Diagram for using a Dinosaur Electronics TDR in a Duo Therm® 900, 9000 66000 & 66100 series (direct spark ignition) furnaces

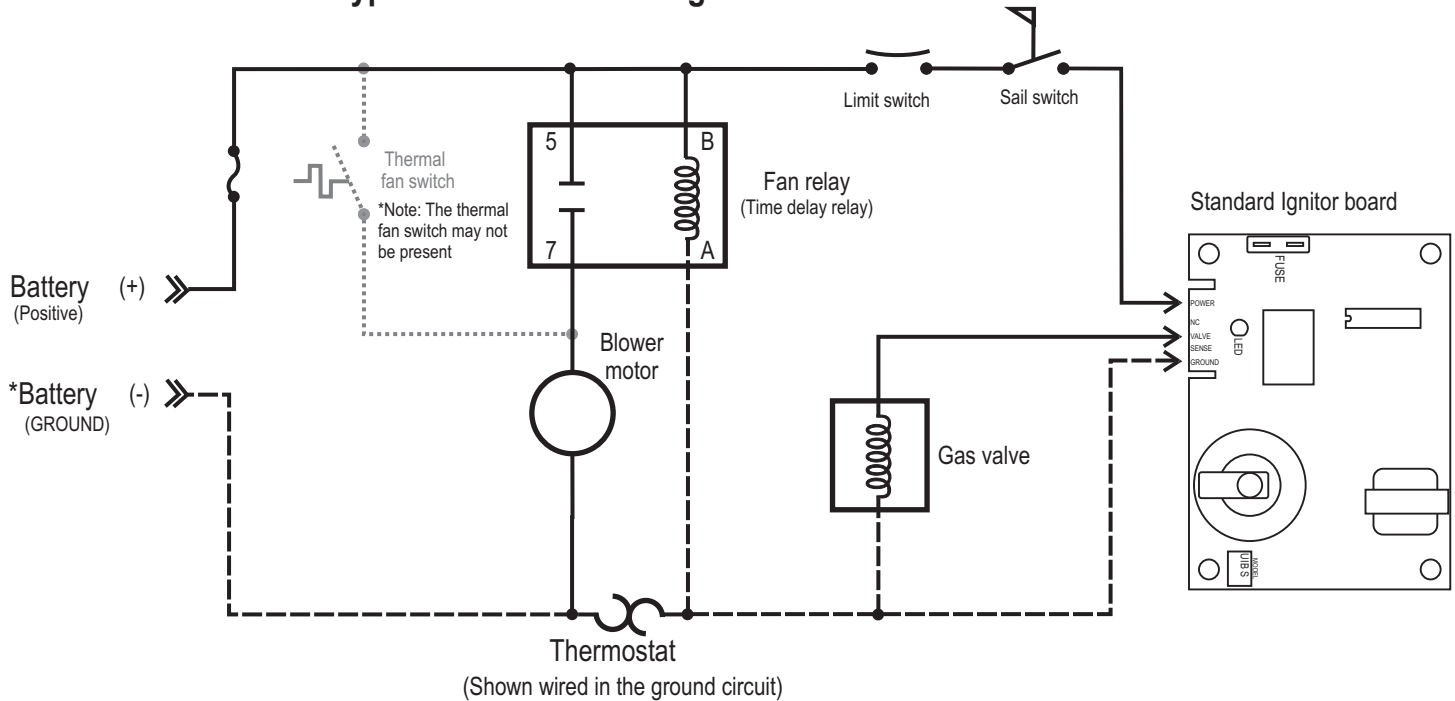
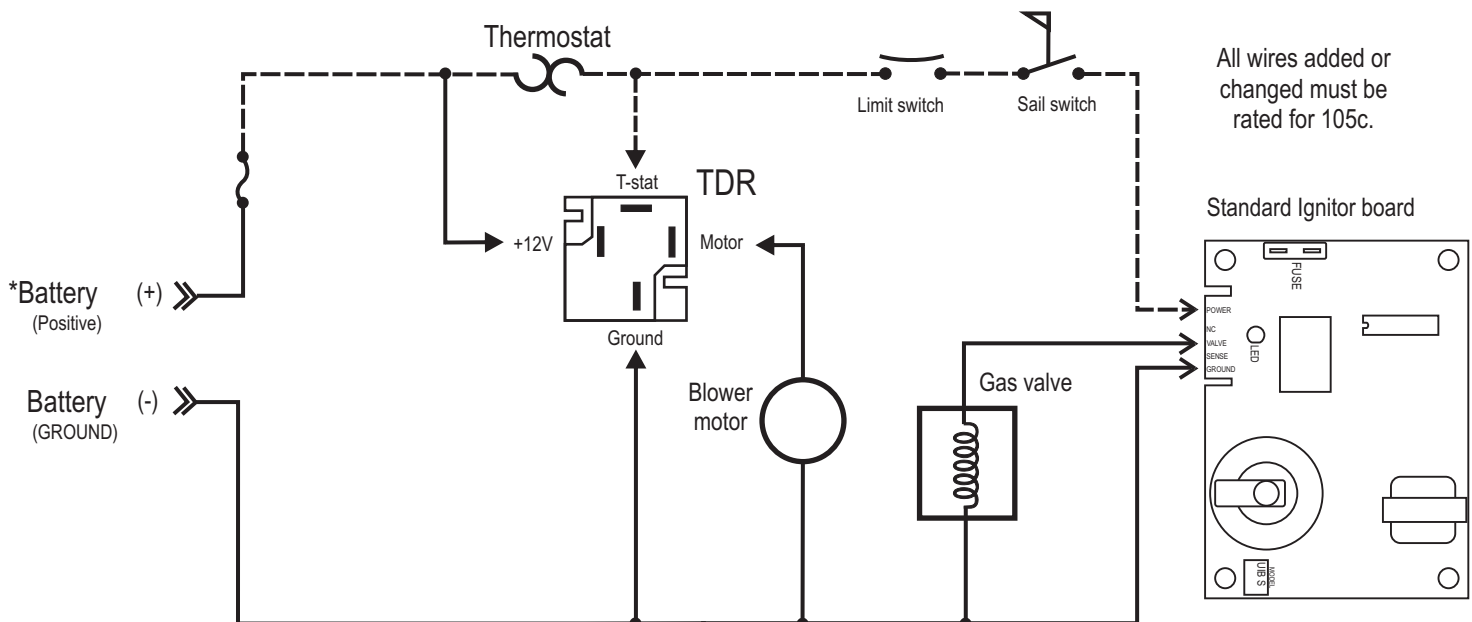
The diagrams shown in this document represent before and after modification of Duo Therm® or any other brand furnace that use a standard direct spark ignition board where the thermostat “controls the furnace” internally in the ground circuitry. The modification will be necessary if you wish to use a Dinosaur Electronics “TDR” (Time Delay Relay) in these furnaces. This document is provided as a courtesy and is to be used AT YOUR OWN RISK! Dinosaur Electronics accepts no liability and provides no warranty whatsoever for the contents or use of this document. This modification should only be attempted by trained professional service technicians. Propane is an explosive gas! Failure to observe proper safety precautions or modifying the furnace incorrectly can result in serious injury or death. You assume full responsibility for any modifications made to the furnace using the information in this document.
